Countries: UNITED STATES, MEXICO **Document ID:** IK0800536
Availability: ISIS, NotSIR **Revision:** 4
Major System: ELECTRICAL SYSTEM **Created:** 2/9/2017
Current Language: English **Last Modified:** 7/27/2018
Other Languages: NONE **Author:** Andrew Boyd
Viewed: 252

Title: LT Starter programming update

Applies To: LT with Auto Start Stop

0597041 – For Cummins Engines

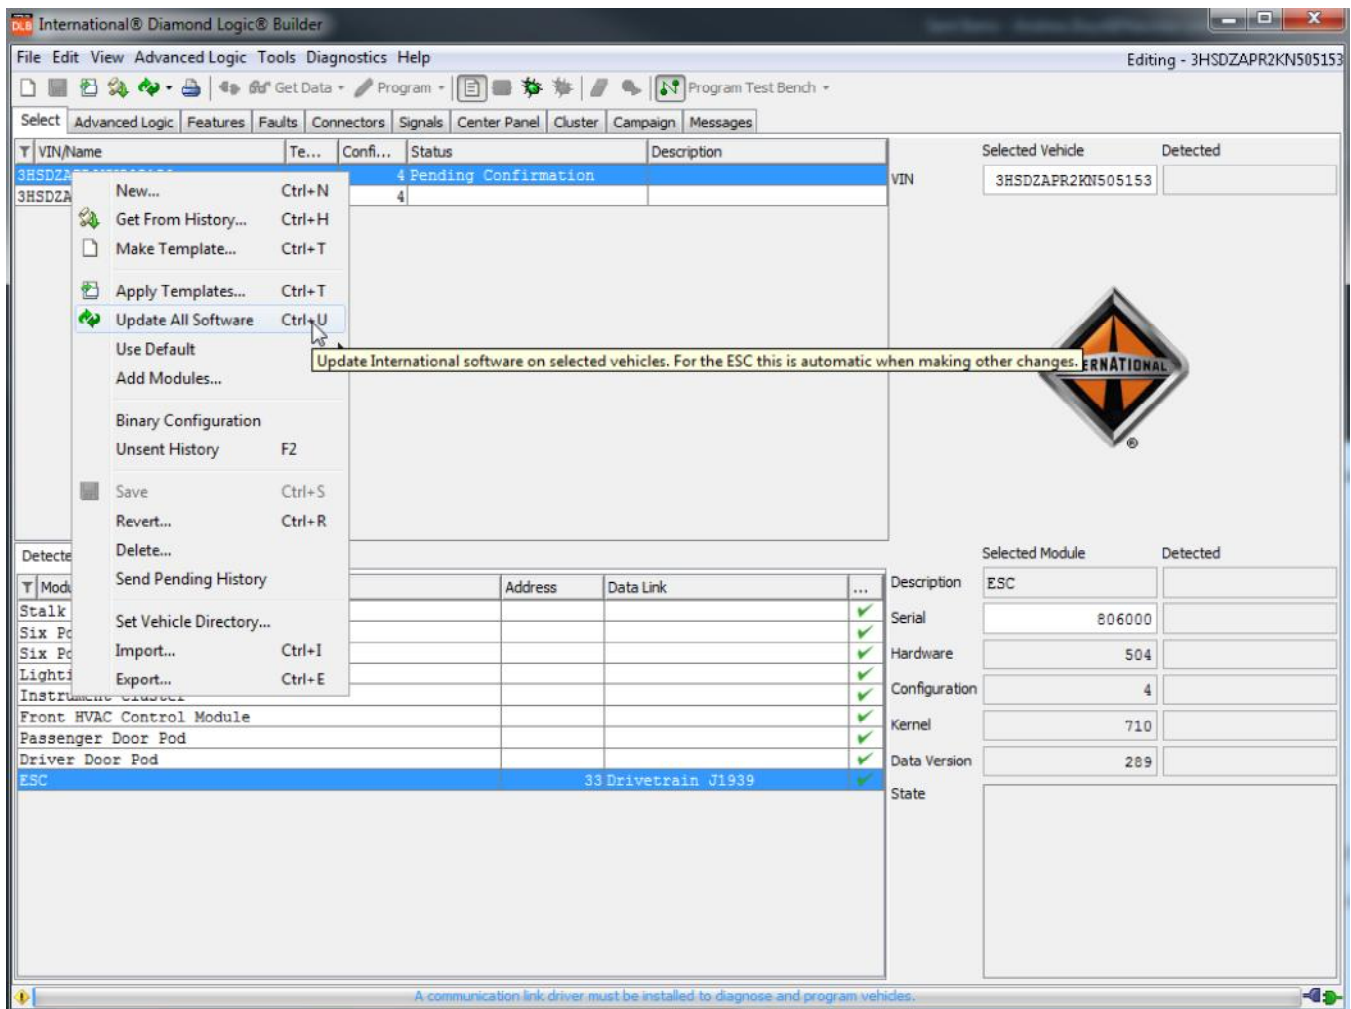
When the body controller is updating to Software version 289, there will be new parameters under the below feature codes.
